Water Right Conditions Tracking Slip

M	ЕМО						_	A	IPRIL	<u>30</u> , 20	<u>E</u> 0				
TO	D *	AĮ	plicati	on G	1589	88									
FF	ROM	G	GW: D. WOODCOCK (Reviewer's Name)												
SU	BJECT		Scenic Waterway Interference Evaluation												
2	Yes No		The source of appropriation is within or above a Scenic Waterway												
5	Yes No	Yes Use the Scenic Waterway condition (Condition 7J). No													
PRI	EPOND	ERAN	CE OF	EVIDE	NCE FI	NDING	: (Che	ck box	only if	stateme	nt is tru	a)			
5	At this time the Department is unable to find that there is a preponderance of evidence that the proposed use of ground water will measurably reduce the surface water flows necessary to maintain the free-flowing character of a scenic waterway in quantities necessary for recreation, fish and wildlife.														
FLC	OW REI	DUCTIO	ON: (Ta	be fille	ed out o	nly if <u>Pr</u>	eponde	erance o	f Evide	nce box	is not o	checked)			
Exe. Wat	Exercise of this permit is calculated to reduce monthly flows in Scenic Waterway by the following amounts expressed as a proportion of the consumptive use by which urface water flow is reduced.

FROM	:	Ground	d Water/	Hydrology	Section _	Douglas Woodcock Review

Depth To Water (feet below ground surface)

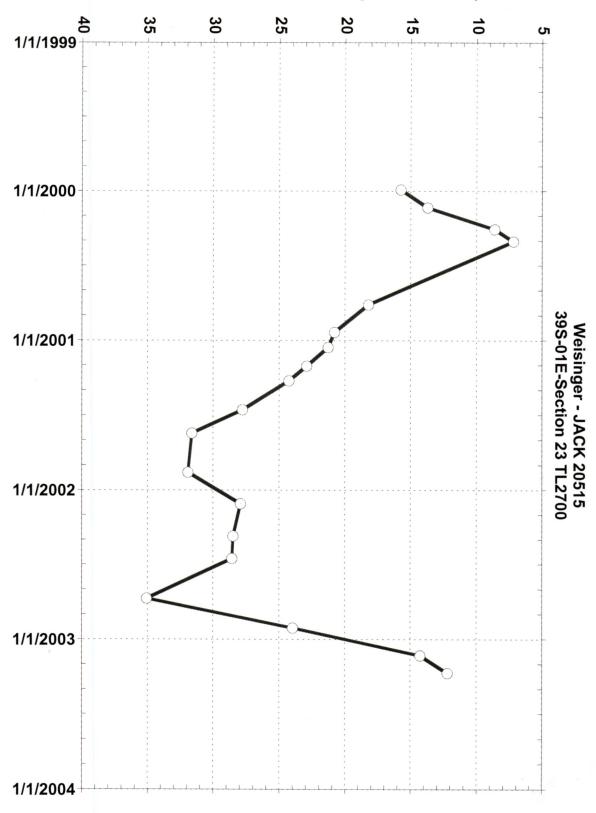
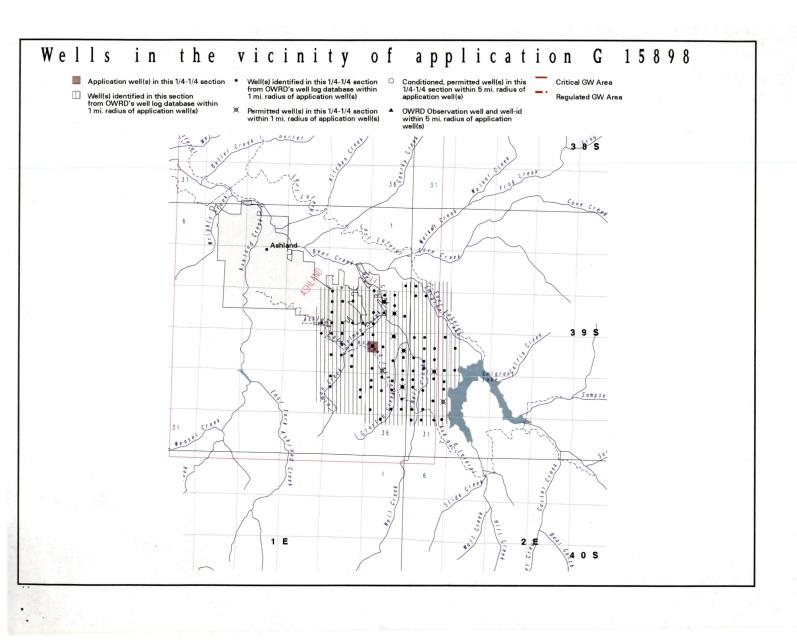
sannot yiel have exp Wee dra Wa stor fluc Cle sun the	ound water availability remarks: The Clear Springs aquifer test demonstrated the confined nature of the deep dstone and the interference that can propagate out from a pumping well. To date, interference between wells does appear acute or substantial. This local area does have above average well yields but is surrounded by lower ding wells. There are several low-yield wells in Crowson Rd area, roughly ~2000 ft to the north. Several of them to been deepened. One of the wells on Crowsen Rd (JACK 20429) has been deepened to 642 feet. That well erienced a nine-foot drawdown in response to the Clear Springs' well test. Though both JACK 20429 and the isinger well (JACK 20515) are equidistant from the Clear Springs well, the Weisinger well saw no apparent wdown during the test (Fererro, 1996). The level data from the Weisinger well and one of the Clear Springs' dedicated observation wells shows GW rage in the aquifers fluctuates with annual precipitation. The Weisinger well is a used well and shows greater cutation over time. Evidence of interference is not evident as only a few measurements are taken each year. The ar Springs is a flowing artesian well and shows less than 10 feet of seasonal fluctuation but has a regular mertime interference of 3-4 ft. This interference is not considered substantial. Both wells show a good response to

sannot yiel have exp We dra Wa stor fluc Cle sum the	bund water availability remarks: The Clear Springs aquifer test demonstrated the confined nature of the deep dstone and the interference that can propagate out from a pumping well. To date, interference between wells does appear acute or substantial. This local area does have above average well yields but is surrounded by lower ding wells. There are several low-yield wells in Crowson Rd area, roughly ~2000 ft to the north. Several of them to been deepened. One of the wells on Crowsen Rd (JACK 20429) has been deepened to 642 feet. That well erienced a nine-foot drawdown in response to the Clear Springs' well test. Though both JACK 20429 and the isinger well (JACK 20515) are equidistant from the Clear Springs well, the Weisinger well saw no apparent wdown during the test (Fererro, 1996). Iter level data from the Weisinger well and one of the Clear Springs' dedicated observation wells shows GW rage in the aquifers fluctuates with annual precipitation. The Weisinger well is a used well and shows greater equation over time. Evidence of interference is not evident as only a few measurements are taken each year. The ar Springs is a flowing artesian well and shows less than 10 feet of seasonal fluctuation but has a regular numertime interference of 3-4 ft. This interference is not considered substantial. Both wells show a good response to wet spring of 2003 after 2 years of lesser rainfall.

sannot yiel have exp We dra Wa stor fluc Cle sum the	ound water availability remarks: The Clear Springs aquifer test demonstrated the confined nature of the deep dstone and the interference that can propagate out from a pumping well. To date, interference between wells does appear acute or substantial. This local area does have above average well yields but is surrounded by lower ding wells. There are several low-yield wells in Crowson Rd area, roughly ~2000 ft to the north. Several of them we been deepened. One of the wells on Crowsen Rd (JACK 20429) has been deepened to 642 feet. That well erienced a nine-foot drawdown in response to the Clear Springs' well test. Though both JACK 20429 and the isinger well (JACK 20515) are equidistant from the Clear Springs well, the Weisinger well saw no apparent wdown during the test (Fererro, 1996). Iter level data from the Weisinger well and one of the Clear Springs' dedicated observation wells shows GW rage in the aquifers fluctuates with annual precipitation. The Weisinger well is a used well and shows greater tuation over time. Evidence of interference is not evident as only a few measurements are taken each year. The ar Springs is a flowing artesian well and shows less than 10 feet of seasonal fluctuation but has a regular innertime interference of 3-4 ft. This interference is not considered substantial. Both wells show a good response to wet spring of 2003 after 2 years of lesser rainfall. Igeneral the area can be summed up as low ground water storage, mixed well yields, and water levels oscillating in ponse to annual precipitation.
